# INNER WEST

## DEVELOPMENT ASSESSMENT REPORT

<b>Application No.</b>	REV/2023/0002
<b>Address</b>	9 Silver Street MARRICKVILLE NSW 2204
<b>Proposal</b>	S8.2 Review of DA/2022/0163, refused on 17 November 2022, to demolish existing improvements, subdivide the land into 2 Torrens Title lots and construct two dwelling houses with associated landscaping
<b>Date of Lodgement</b>	28 January 2023
<b>Applicant</b>	Mr Youssef Moussa
<b>Owner</b>	Mr Ali Ahmad Mrs Fatat Ahmad
<b>Number of Submissions</b>	Initial: 1
<b>Value of works</b>	\$770,011.00
<b>Reason for determination at Planning Panel</b>	No substantial change to original determination of 8.2 review
<b>Main Issues</b>	Subdivision Pattern, Streetscape and Design, Visual Bulk and Scale, Visual/Acoustic Privacy and Overshadowing
<b>Recommendation</b>	Refusal
<b>Attachment A</b>	Reasons for Refusal
<b>Attachment B</b>	Draft Conditions in the Event the Application is Approved
<b>Attachment C</b>	Plans of Proposed Development

Figure 4: Proposed Plan of Subdivision

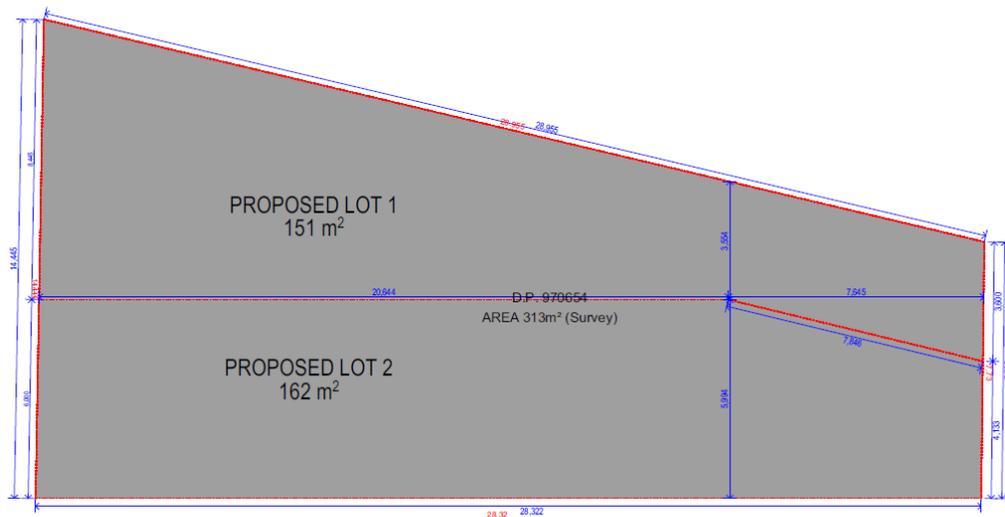
The proposed Lot Size of Lot 1 would be considerably smaller than other lots and therefore the proposal fails to meet the requirements of Control 5 in relation to lot size and shape.

In addition to the above, for reasons discussed throughout this report the proposed development will result in adverse amenity impacts on surrounding properties and the development is not considered to be consistent with the streetscape character and built form character in the vicinity and fails to provide adequate parking. Therefore, the development is inconsistent with the abovementioned controls and objectives contained in Part 3.2.2 of MDCP 2011 given the proposed lots would not be able to accommodate development that is compatible with the surrounding area.
